UN Regulation No. 125

FORWARD FIELD OF VISION

GRSG / UN-R125 scope extension and partitioning system

Status of the exchanges between the Members States and the OICA
members

Folded position

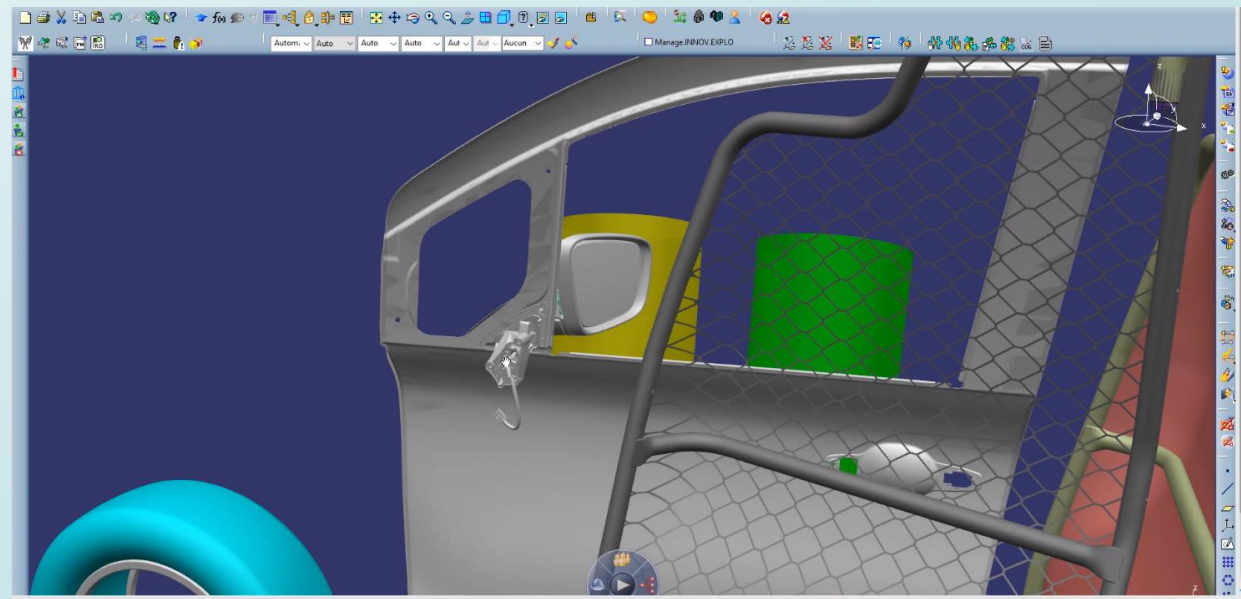
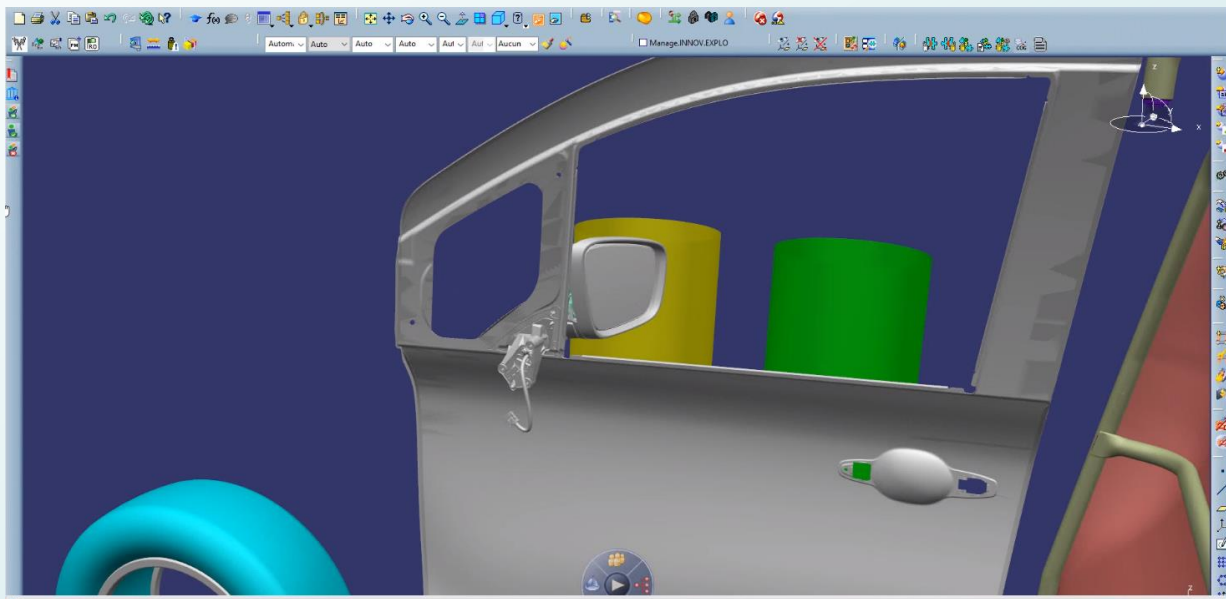
- When folded, requirements of the part behind the driver
 - Separation between the occupant compartment and the loading space, in terms of driver protection zone width and height
 - Maximum 40 mm between the partitioning system and the vehicle body
 - 2 Strength tests + 1 grid dimension test (object having a front surface of 50×10) mm

- When folded, requirements of the folded part:
 - No test for the folded part of the partitioning system
 - The driver seating position is sufficiently protected against laterally shifting cargo.
 - Separation between the occupant compartment and the loading space, in terms of height no defined
